Planning Commission Comments - February 6, 2023 - Submission #68649

7. 3675 Thompson Bridge Road, 3510 Southers Road, 3709, 3719, & 3739 Price Road | Rezone

SR 60 -- SR 136-ver1-2.pdf

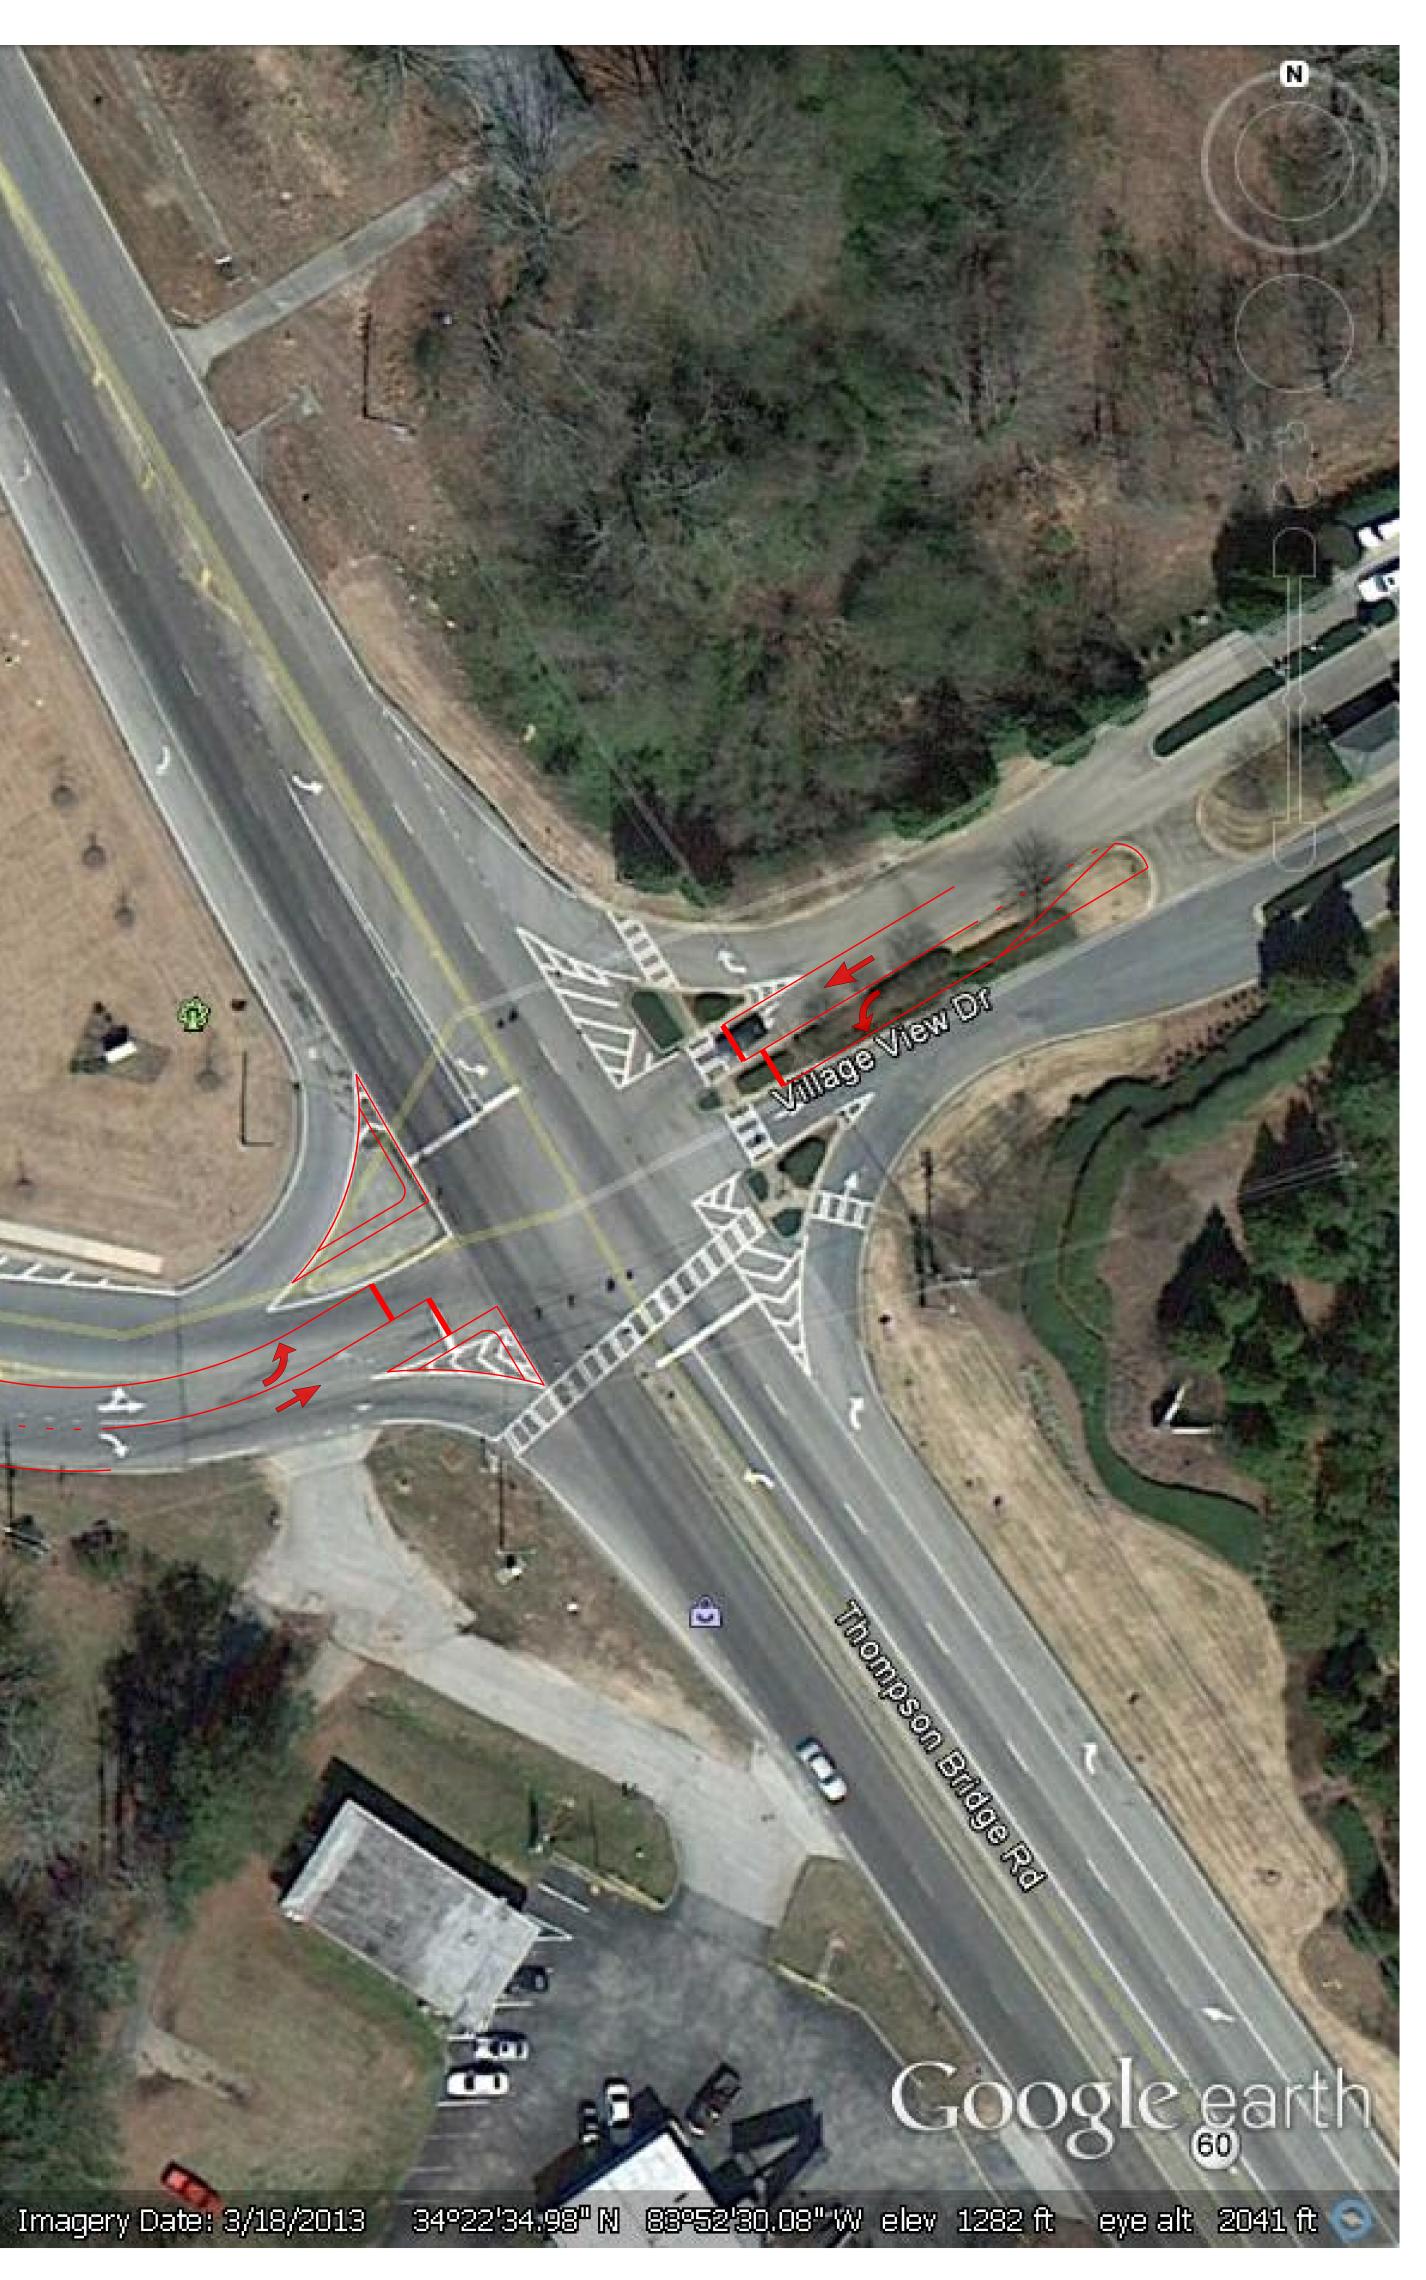
We are hopeful that NGHS and the developers for the previously mentioned projects might coordinate with the GDOT to implement traffic flow and lane improvements for that intersection, including dedicated left turn lanes for northbound and southbound traffic for Thompson Bridge. (Please see attached file for illustration.) Let's not wait until we have another serious accident there before action is taken. Thank you!
